Moon Roof - Creak Noise

NV008-01

MOON ROOF CREAK NOISE

'00 Celica

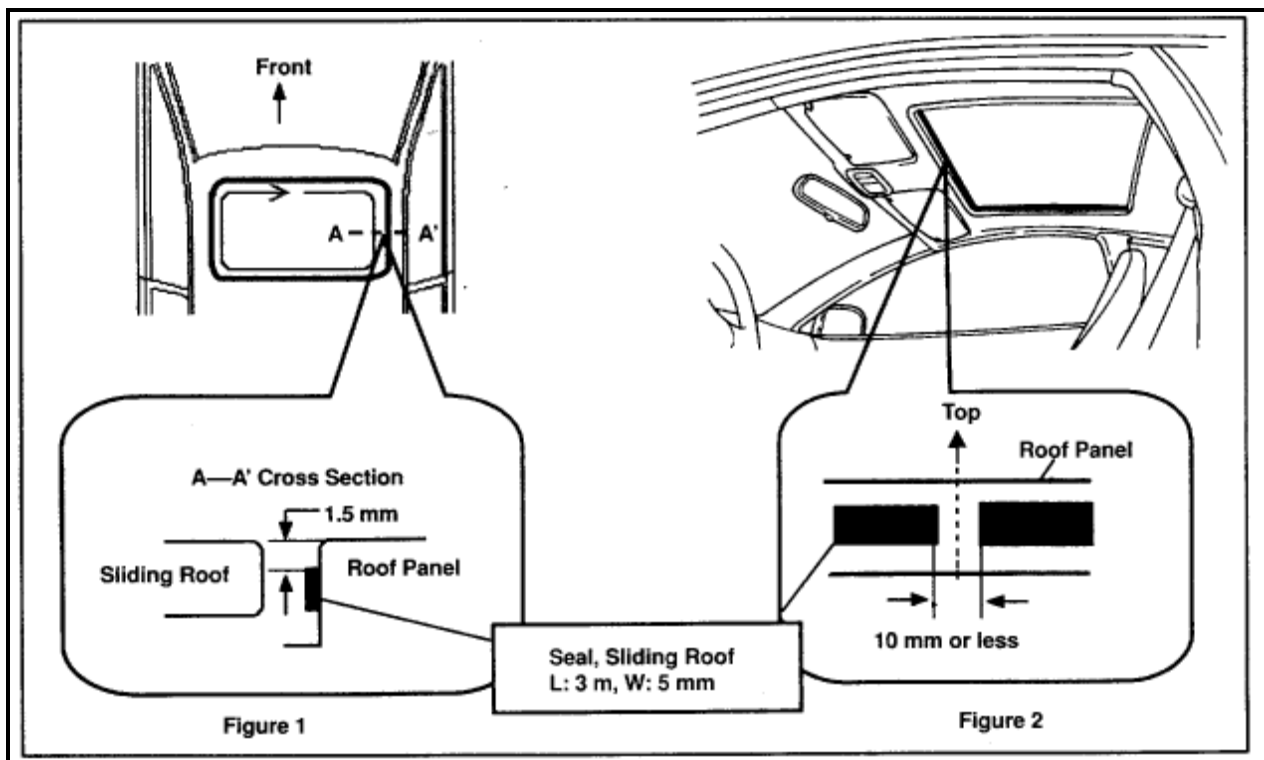
Applying position of the Seal to roof panel top surface - 1.5 mm (See Figure 1).

- b. Cut the [Sliding Roof](#) Seal so that the gap will be 10 mm or less and the ends may not overlap (See Figure 2).
- c. Press the [Sliding Roof](#) Seal to let the air out of it.
3. Clean the outside of the moon roof weatherstrip.
